Report to the Secretary of State for Transport and the Secretary of State for Levelling Up, Housing and Communities

Date: 4 October 2022

**THE NETWORK RAIL (CAMBRIDGE SOUTH INFRASTRUCTURE
ENHANCEMENTS) ORDER 2021**

**REQUEST FOR A DIRECTION UNDER SECTION 90(2A) OF THE TOWN AND
COUNTRY PLANNING ACT 1990 FOR DEEMED PLANNING
PERMISSION**

Proposed Station and platforms (Plan number 158454-ARC-ZZ-ZZ-DRG-LEP-000051)

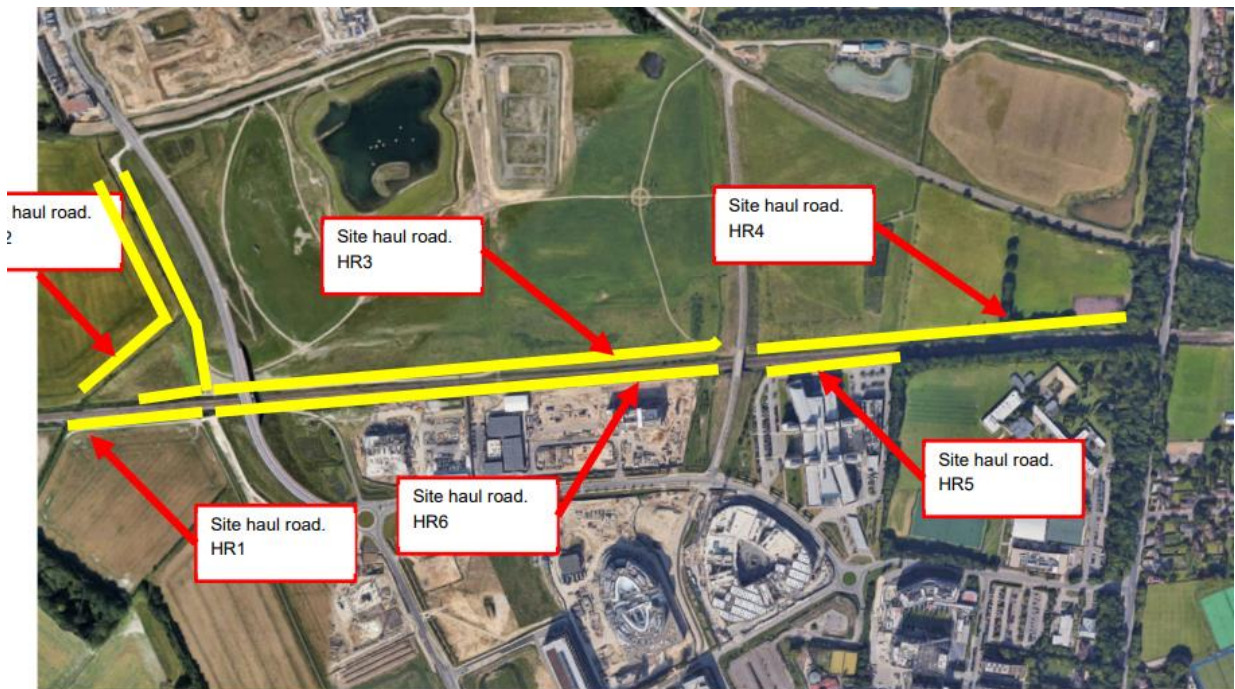
- 4.20 Notwithstanding this, the plans are inconsistent in respect of the extended cycle parking area. Plan Number 158454-ARC-ZZ-ZZ-DRG-LEP-000051/ P02 has been updated as in the Schedule, however these changes are not reflected on other plans, including the Illustrative Station Layout Plans²³ or the Indicative Landscape plan²⁴. Whilst it is appreciated that these plans are for illustrative purposes only, the Plan 158454-ARC-ZZ-ZZ-DRG-LEP-000051/P02 refers to Plan 158454-ARC-ZZ-ZZ-DRG-LEP-000081 in relation to the detailed layout of the station forecourt. Therefore, for the avoidance of doubt, the SoS may wish to seek amendments to the other plans prior to granting Deemed Planning Permission.
